Proposed Corriegarth 2 Wind Farm: Response to SEPA Consultation Request

Appendix A – Amended Figures

Corriegarth 2 Wind Farm

Figure 13.2.2a

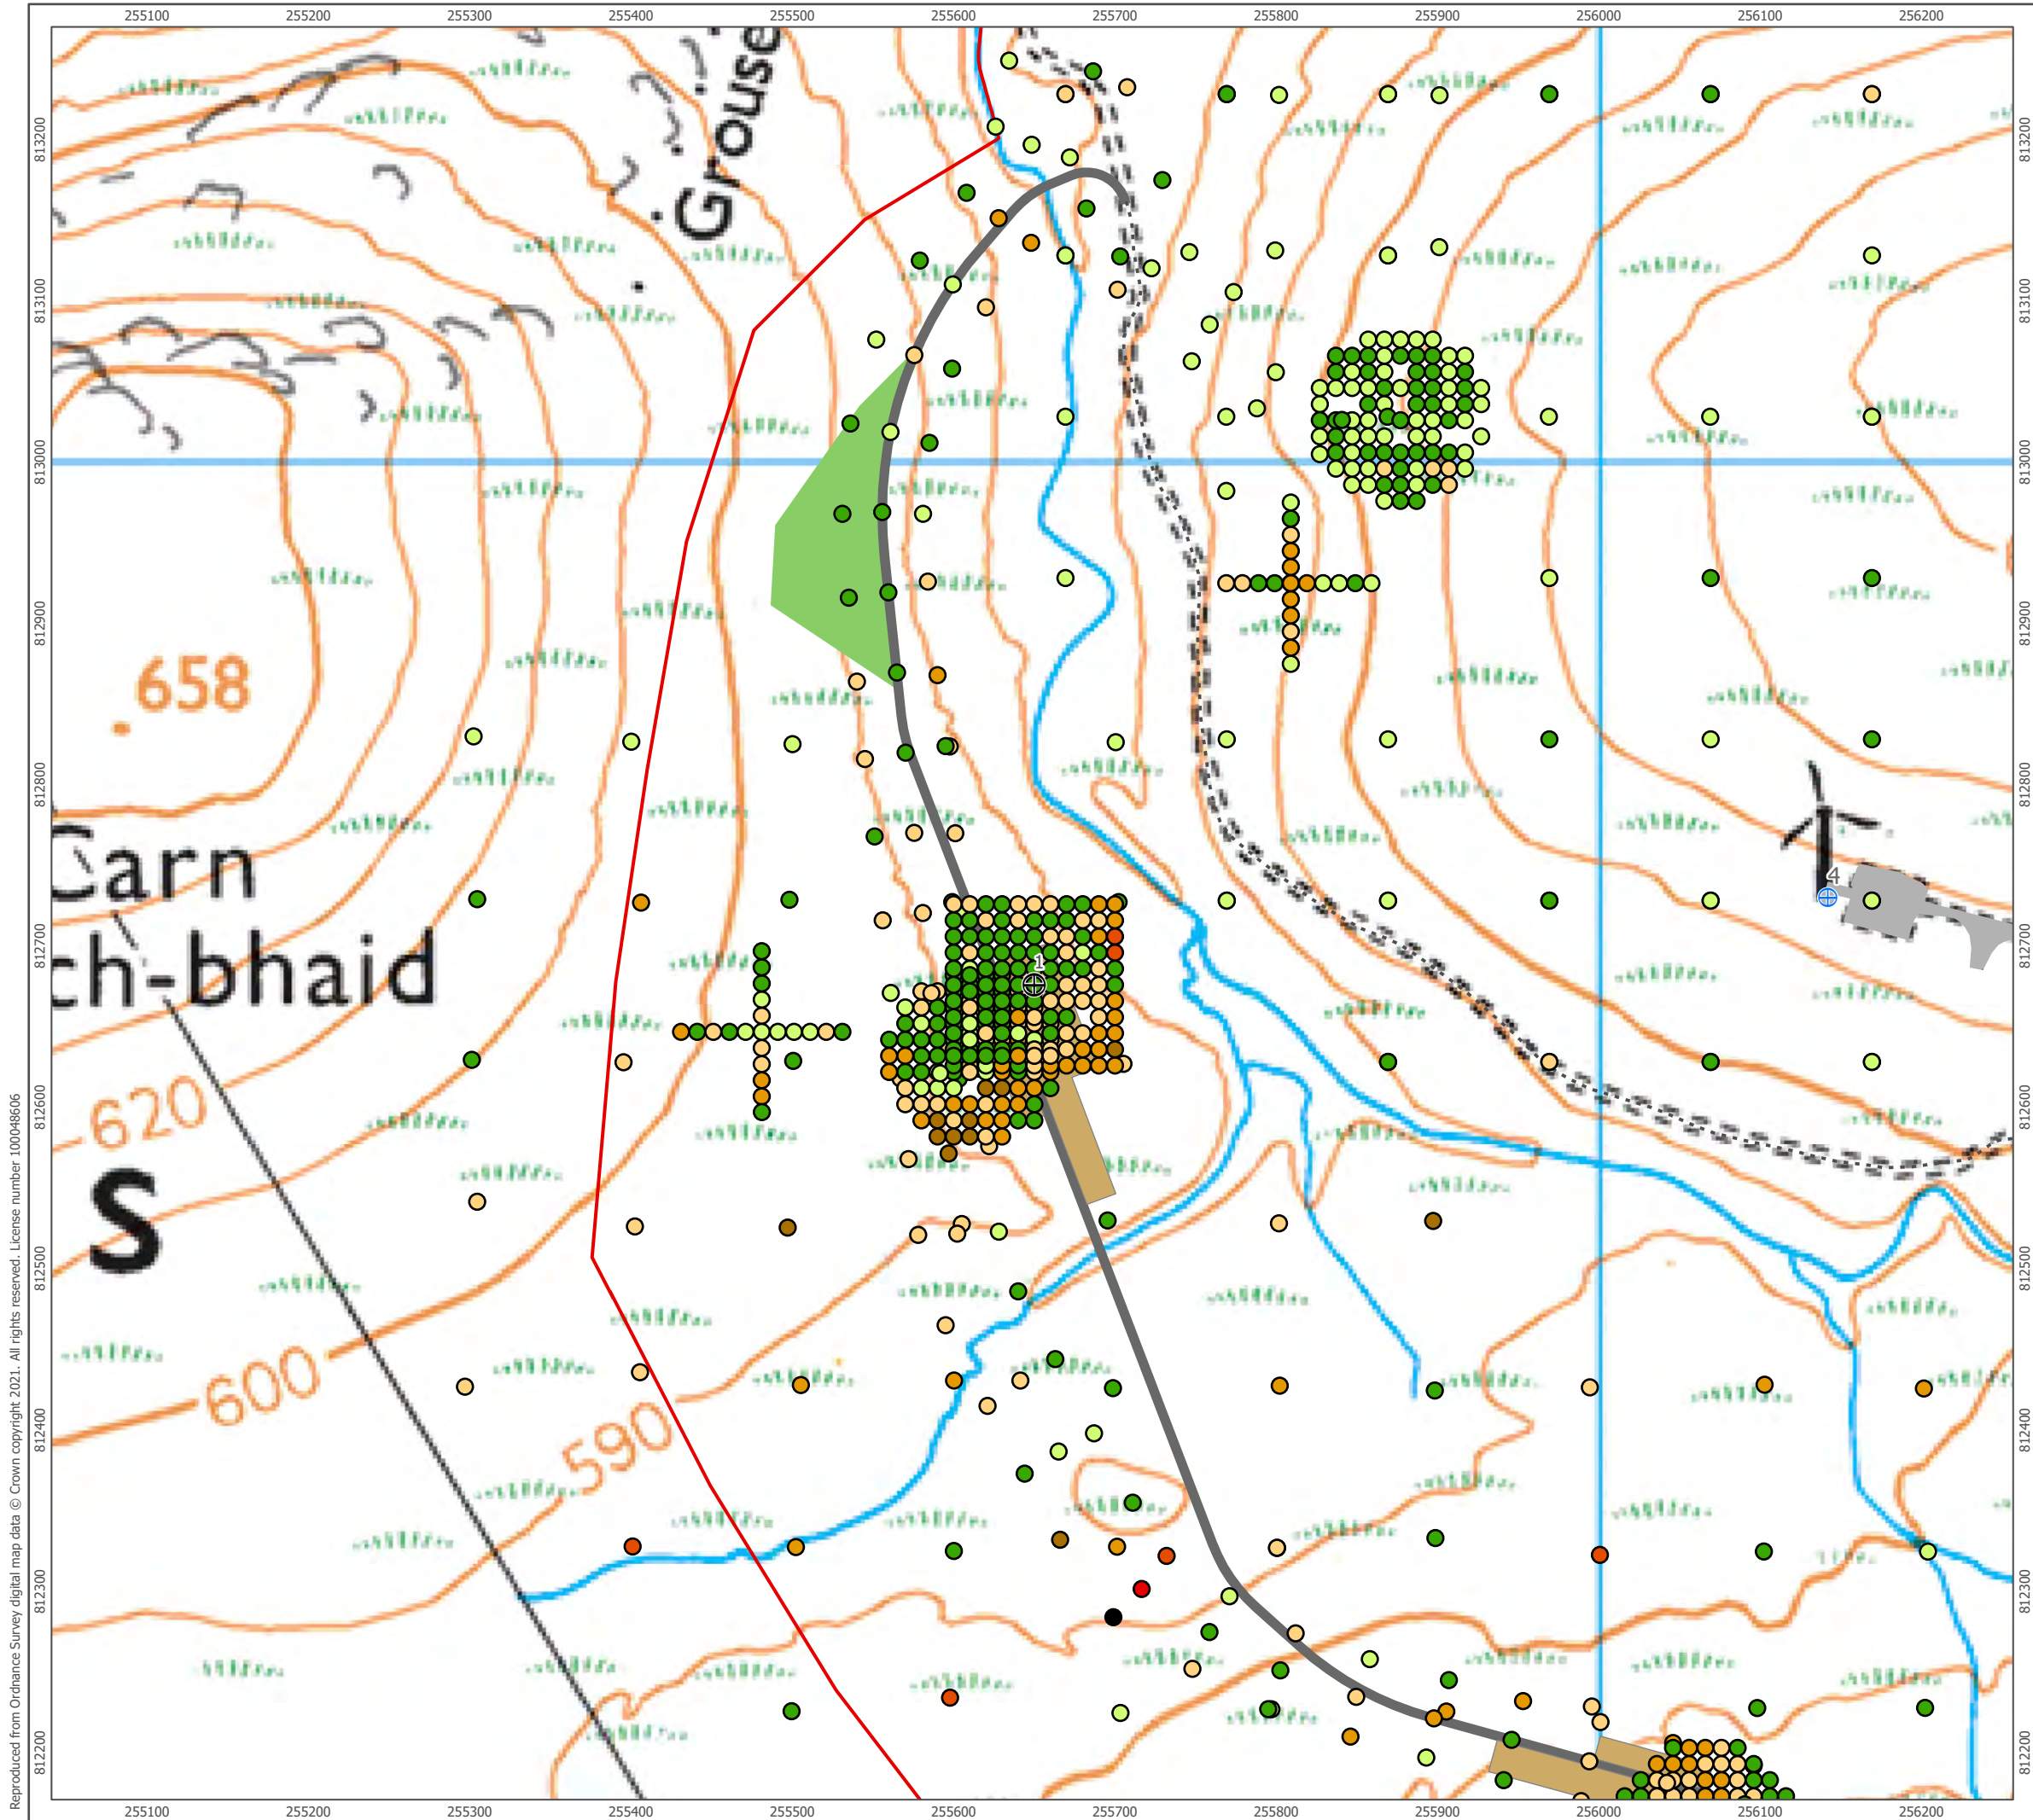
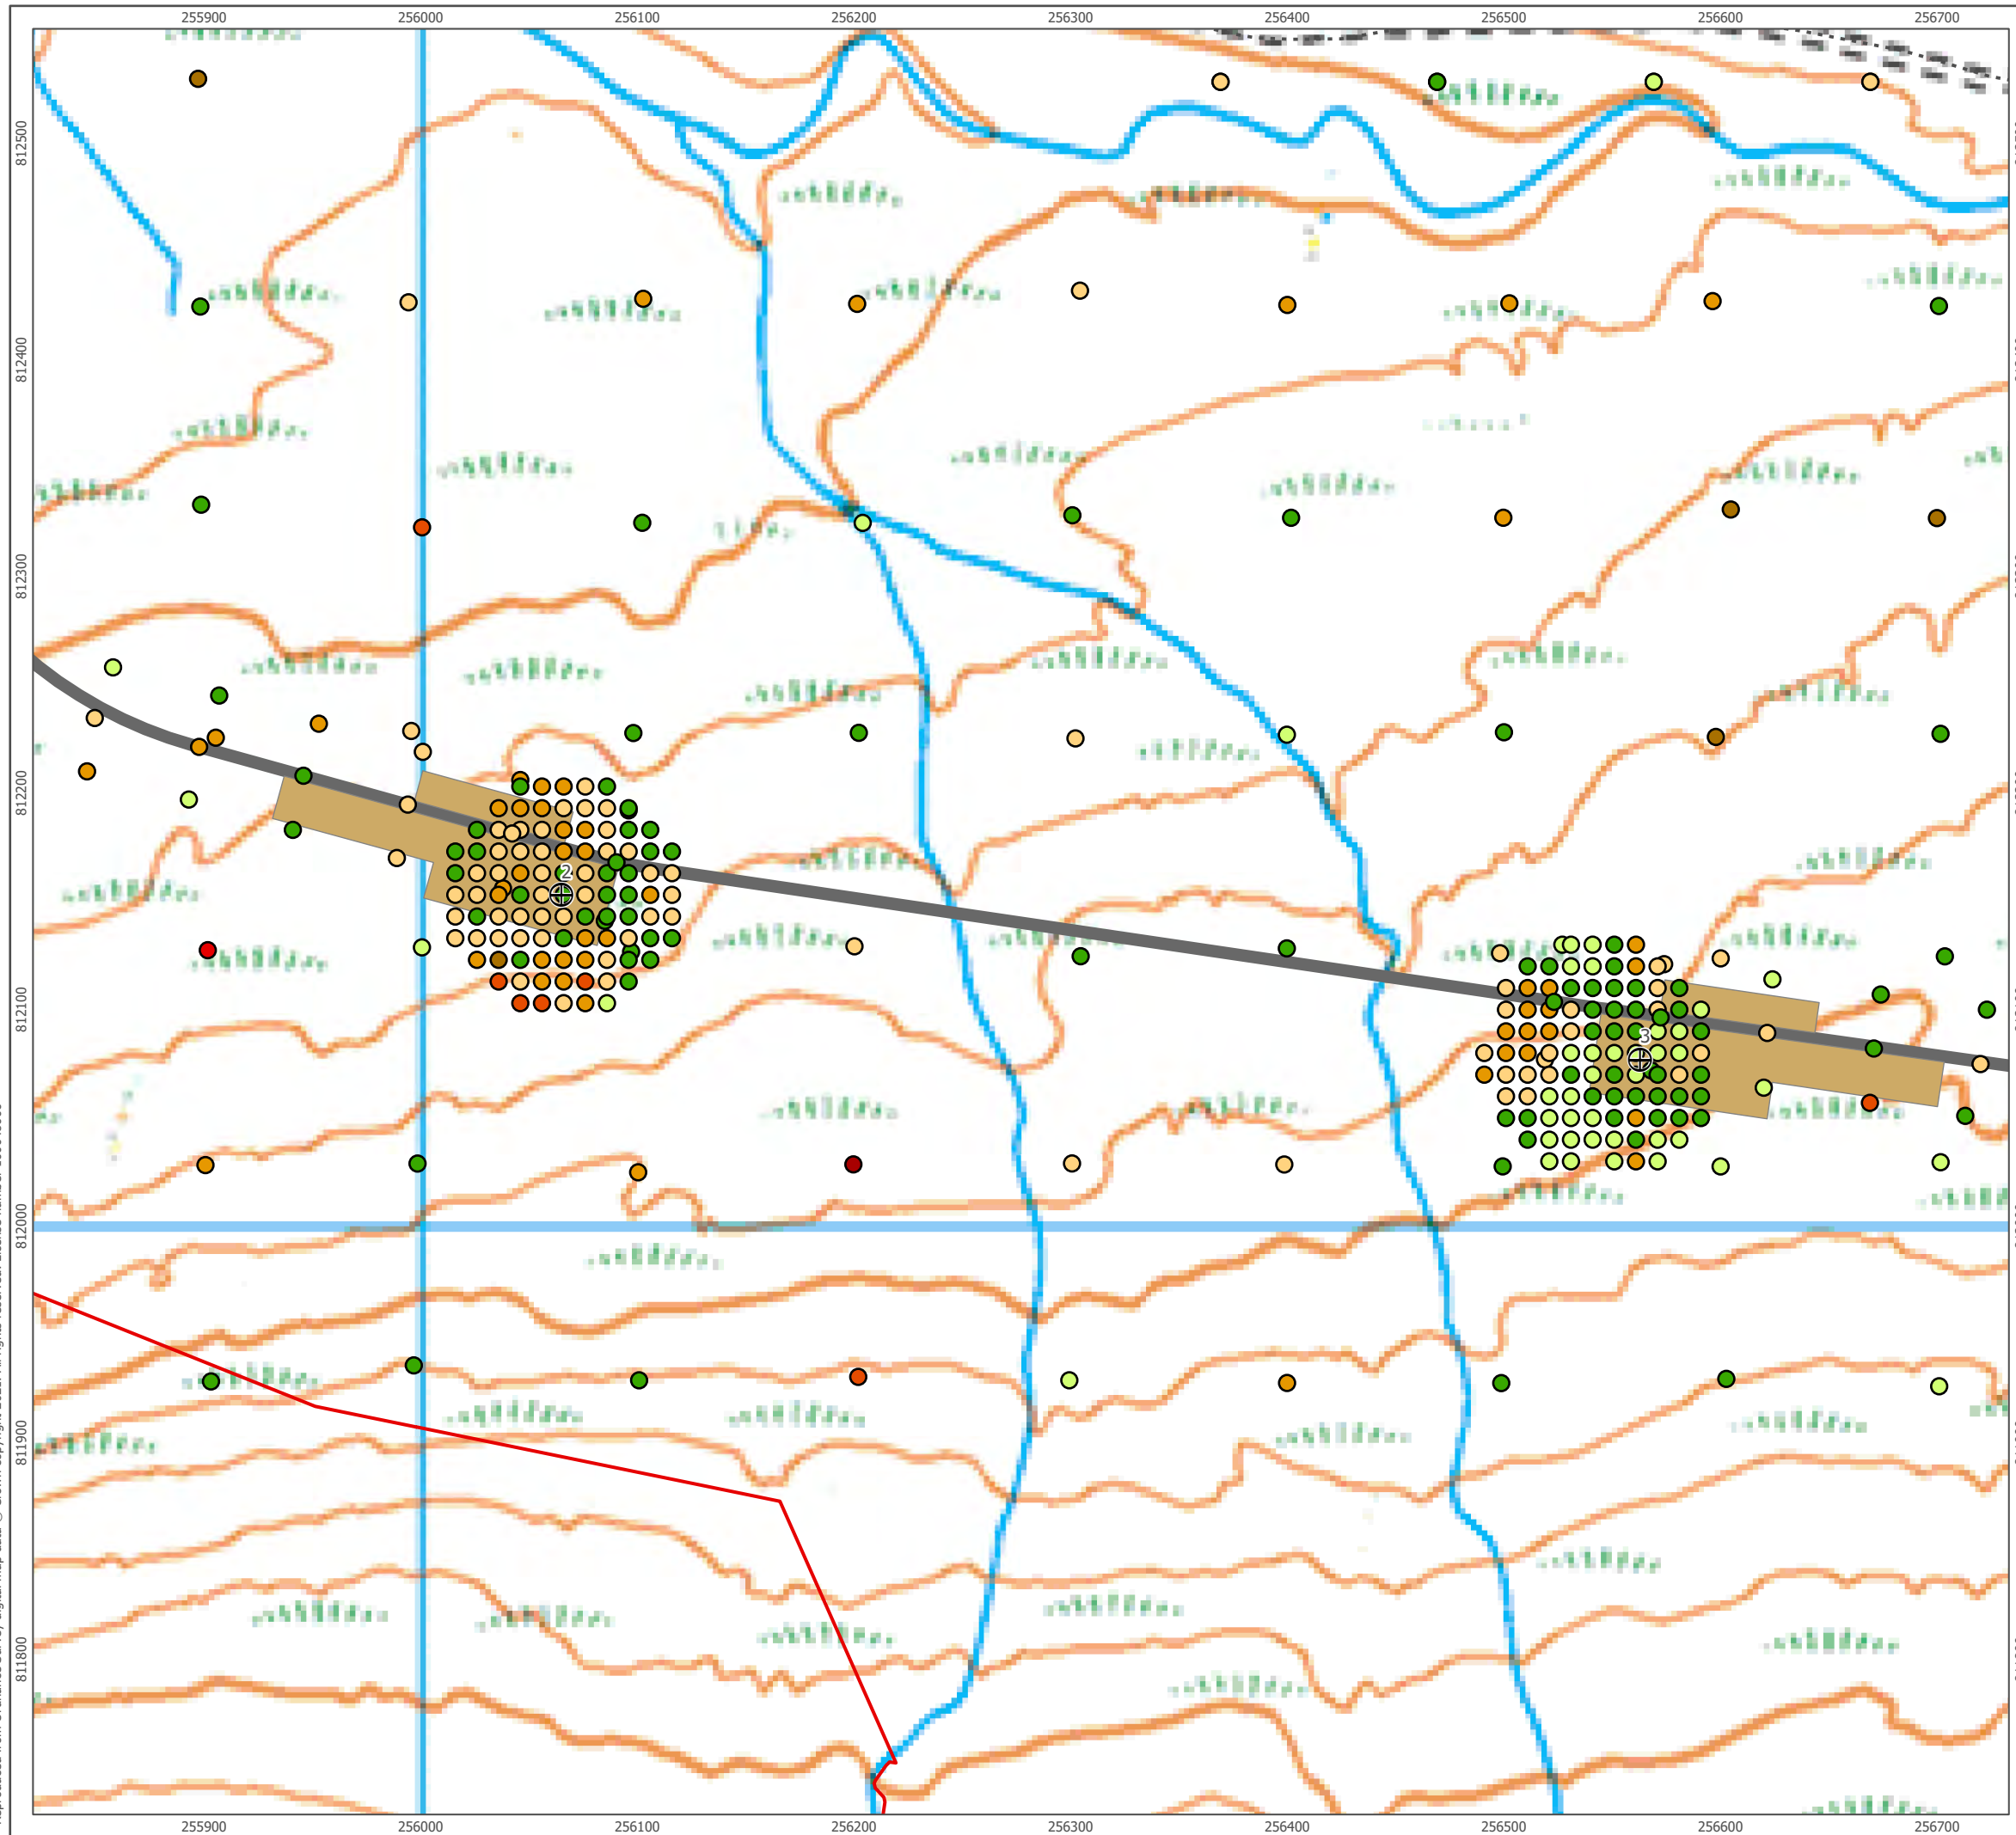
1. Figure 7.2 of Chapter 7: Ecology of the EIA Report is amended to include all proposed infrastructure associated with the Development (clearly marked);
2. All of the figures contained within Technical Appendix A7.1: Habitats and Botany Surveys to include all proposed infrastructure associated with the Development (clearly marked); and
3. Figure 13.2.2 of Technical Appendix A13.2: Outline Peat Management Plan to be provided on OS Basemapping; to be provided in a map series format; and with a revised symbology colour ramp.

3.	Figure 13.2.2 has been amended to include 25k OS Basemapping, as requested. Additionally, the figure is now spread over several maps providing a more appropriate scale for the reader to understand the peat probe depths more accurately in relation to infrastructure. A revised colour ramp has also been provided.
